GEORGIA-PACIFIC CORPORATION
BESTWALL GYPSUM DIVISION

Addendum to General Sales Bulletin #60-66
August 30, 1966

SUBJECT: SUSPENDED CEILINGS WITH FIRESTOP
RE: Incombustible Assemblies

SUSPENDED FLOOR-CEILING CONSTRUCTION
⅝" TYPE X GYPSUM WALLBOARD

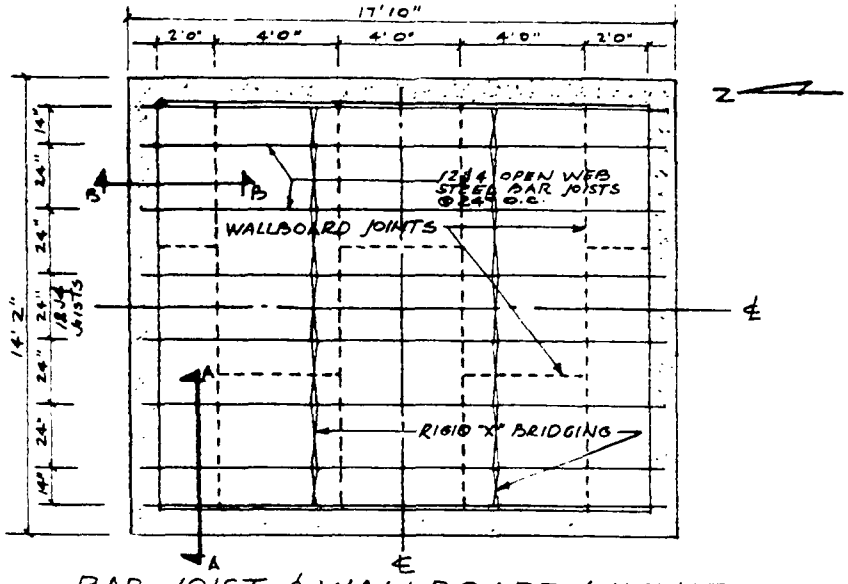
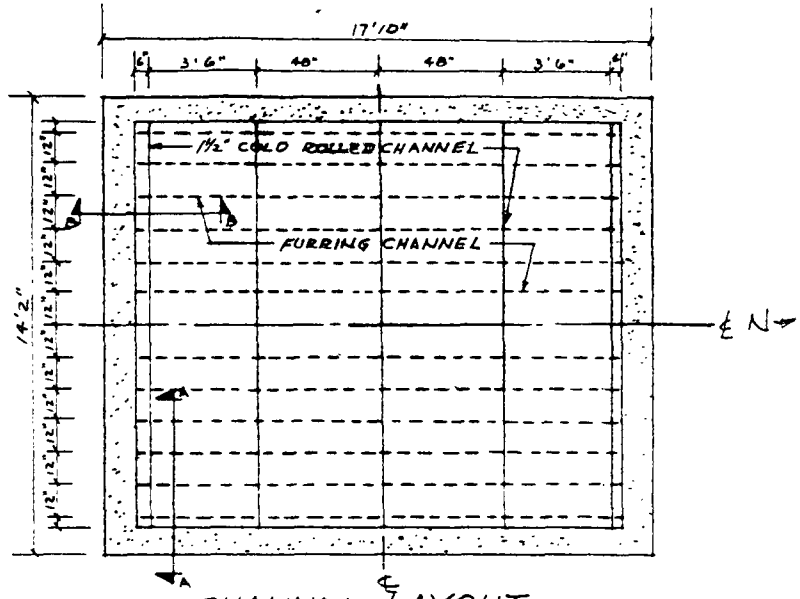
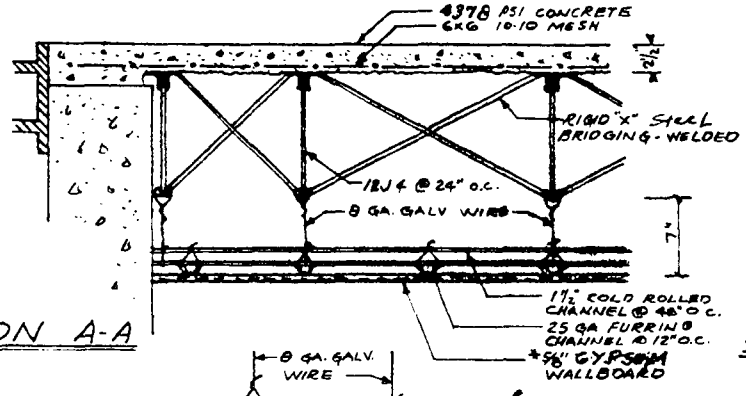
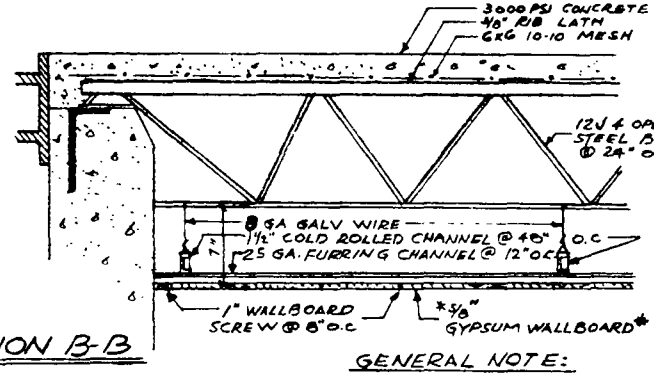
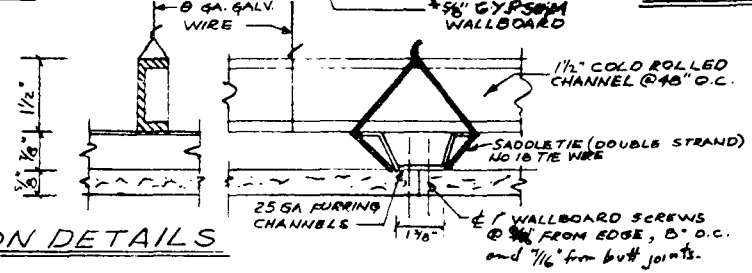
It has been brought to our attention that additional information should be submitted to clarify the method in the construction of an incombustible suspended floor and ceiling assembly as described in General Sales Bulletin #60-66. Please delete the second and third paragraphs of the bulletin and substitute the following description.

In the duplicate fire test, 1-1/2" cold rolled channels (16 gauge) were suspended at right angles to the bar joists and spaced 48" on center and suspended from the bar joists with 8 gauge galvanized steel wire spaced 48" on center along cold rolled channels. 25 gauge furring channels were double wire tied with 18 gauge steel wire at right angles to the cold rolled channels and spaced 12" on center and tied at every intersection. One layer of 5/8" Type "X" gypsum wallboard, screw attached to the furring channels, with the wallboard applied perpendicular or at right angles to the furring channels

The list of assemblies covered under this duplicate test to substantiate direct attachment or suspended attachment of one layer of fire rated gypsum board in an incombustible suspended ceiling are: UL #2,1-hr; UL #19,1-hr; UL #17,1-1/2 hr; UL #13,1-1/2 hr; UL #237,2-hr; UL #69,2-hr; and UL #259,2-hr.

Attached is one copy of suspended ceiling construction details as constructed in the Gypsum Association duplicate fire test.
